**Response to Regulatory Comments
for
Final Focused Feasibility Study/TI Waiver for MARBO Groundwater
Andersen Air Force Base, Guam**

Item	Page	Section	Comments	Response to Comments
Comments provided by EPA Region IX RPM (M Ripperda) in 7/24/08 email				
Focused Feasibility Study Comments				
1	4, last bullet		Please avoid phrases like “conditions are far too toxic...” Either explain the geochemical problems or delete this sentence. Likely “conditions are not favorable” is better	The last bullet point in section 3.0, page 5 now reads “Groundwater geochemical conditions are <i>not favorable</i> for biological reductive dehalogenation.”
2		2	Please include a short description of island groundwater lenses, particularly vertical chloride gradients and the transition zone. A more detailed explanation also needs to go in the TI Waiver Justification, Section 7. as part of the conceptual site model	An additional bullet point was added to section 2.0, page 3 to provide additional description of freshwater lenses. Cross-sectional diagrams illustrating the relationship between lens thickness, time, chloride concentration, and contaminant concentrations were incorporated. (Figures 3 and 5)

*

Figure 8-1.
Plan View of Spatial Extent of Technical Impracticability Waiver Based on Historic Long-Term Groundwater Monitoring Data, MARBO Annex Operable Unit, Andersen AFB, Guam.

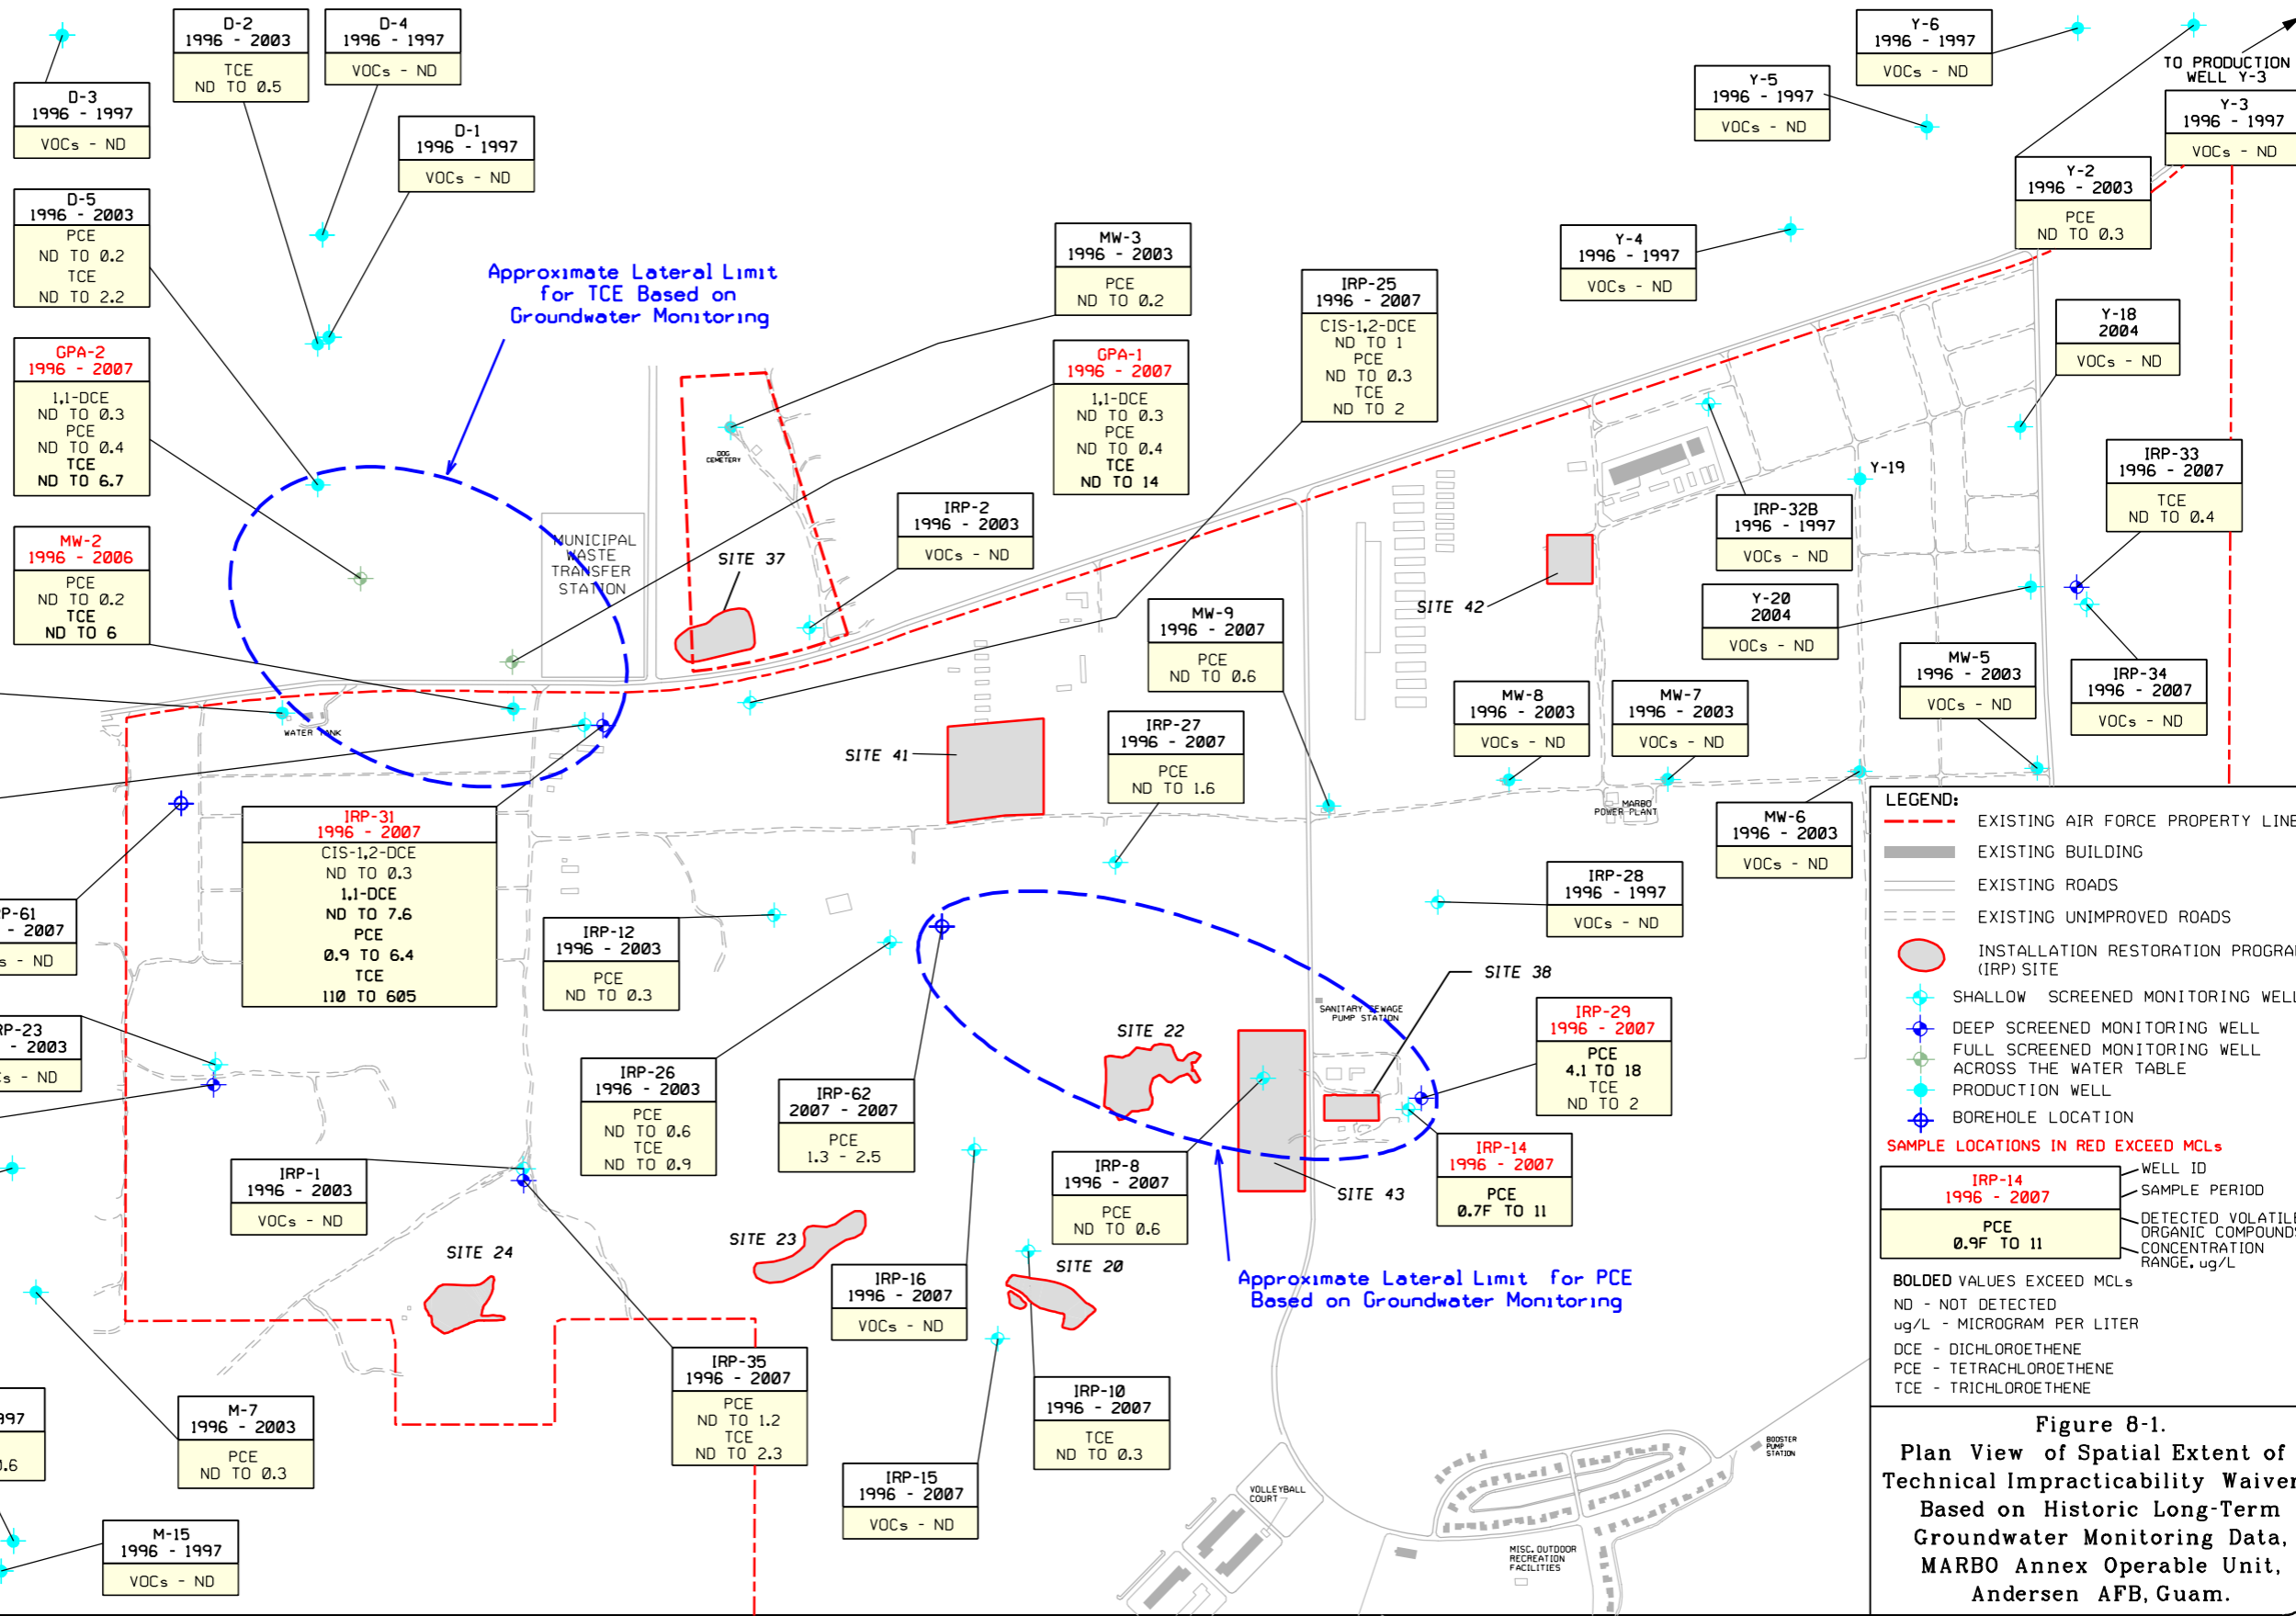
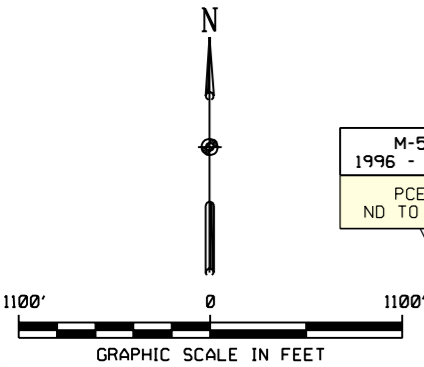
18		Figures	Please add concentration versus time graphs for the deep wells and any key shallow monitoring wells and production wells.	Attachment 1 contains well graphs of contaminant concentration versus time for shallow and deep wells in the vicinity of the TCE and PCE occurrences. Reference to Attachment 1 was made in the second paragraph of Section 8.1.
19		Figure 8	does not show the TI zone..should be depicted here and in cross-section	Acknowledged. Figure 8 was corrected to indicate spatial limits of TI waiver and is now entitled Figure 8-1. Additionally a cross section was added (Figure 10-1).
